Proposal for Corrigendum to Regulation No. 48

Submitted by the Chair of the task force on conspicuity marking of the Working Party on Lighting and Light-Signalling. The text reproduced below was prepared by the experts of the task force on "Conspicuity Marking" of the Working Party on Lighting and Light-Signalling (GRE), by discussing the question on marking of the cab of a motor vehicle, as agreed during the sixty-sixth session of GRE (see ECE/TRANS/WP.29/GRE/66 para. 7). The modifications to the existing text of the Regulation are marked in bold for new or strikethrough for deleted characters.

Motor vehicle

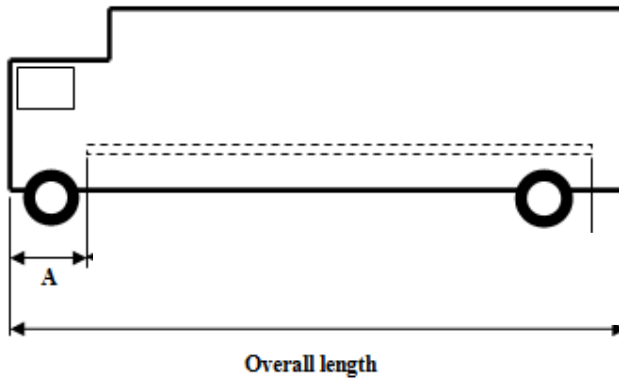
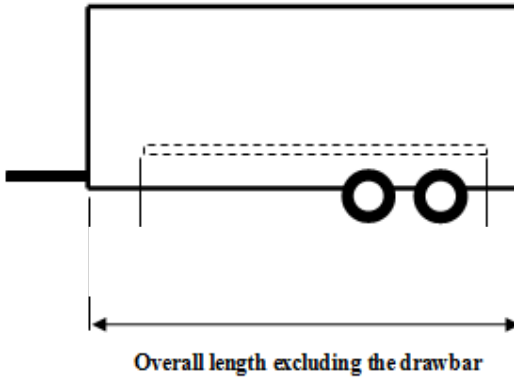
6.21.4.2.2.1. for motor vehicles, length of vehicle ~~excluding the cab~~, or in the case of tractors for semi-trailers, if fitted, the length of the cab; **however, when using the alternative marking mode per 6.21.4.2.1.1., the distance beginning within 2400 mm of the front of vehicle to its rear end.**

A = "alternative marked front", is the distance between the foremost conspicuity marking and the front end of the vehicle (in case of trailers excluding the drawbar). The maximum value of **A** is **2400** mm (see paragraph 6.21.4.2.1.1.).
